FL1

93.04

Service Information

Fig. 7.1

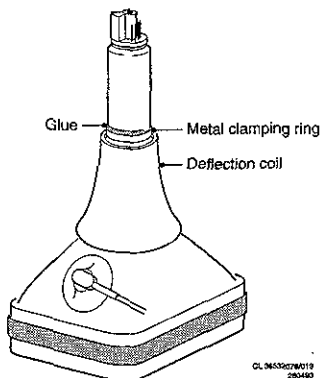
In order to prevent the deflection coil from dropping down following the replacement a projection tube the deflection coil should be firmly attached to the new projection tube. To achieve this adhesive 4822 390 30066 may be used. The adhesive should be applied to half of the tube's circumference (see Fig. 1), thereby coming into contact with the projection tube, the metal clamping ring and the plastic on the deflection coil.

Fig. 7.2

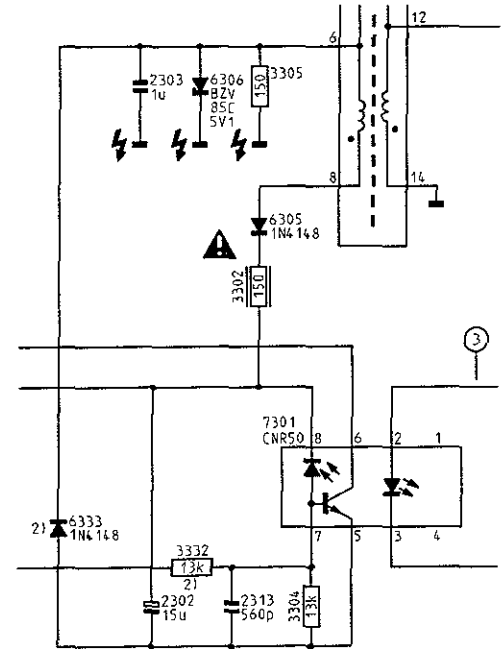
In service manual FL1-PTV AA a part of diagram x is incorrectly illustrated. This part is shown correctly in Fig. 2.
